Release Notes for MotionWorks IEC

Release 1.2.2 Build 7

Yaskawa Electric America, Inc.

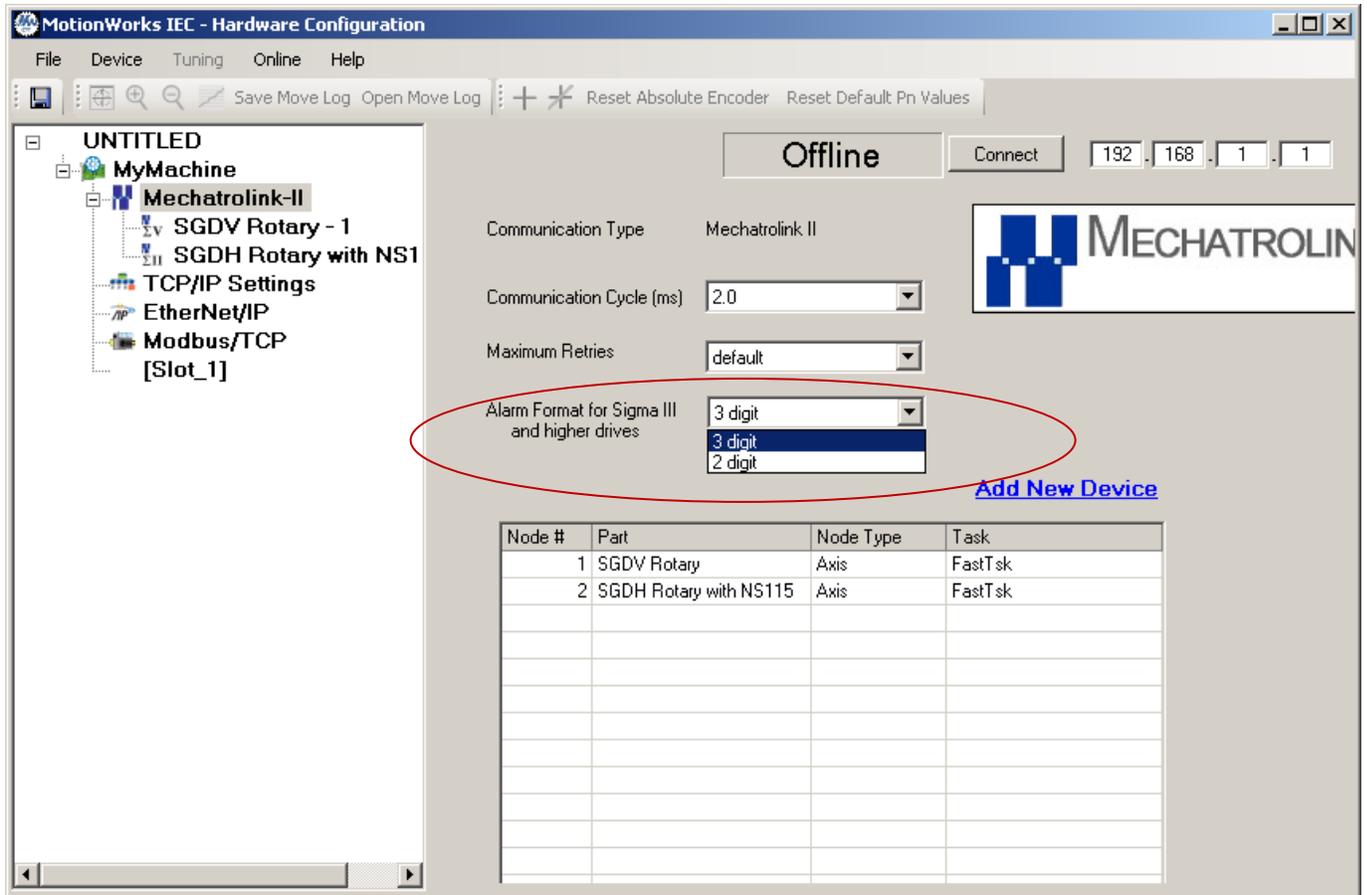
- Adopted fixed addressing for hardware devices
 - New devices are given a fixed address space based on their configuration
 - Addressed for existing devices are converted to the fixed address space
- User Assigned Modbus Addresses Variables & I/O Groups
 - The address range for each Modbus Data Block must be assigned when the device is configured
- New Sigma-5 Variables
 - New variables were added for Sigma-5: ALM, WARNG, PON, SVON, PSET
 - The ServoPack I/O naming was changed to the following, which more closely relates to the Sigma documentation.
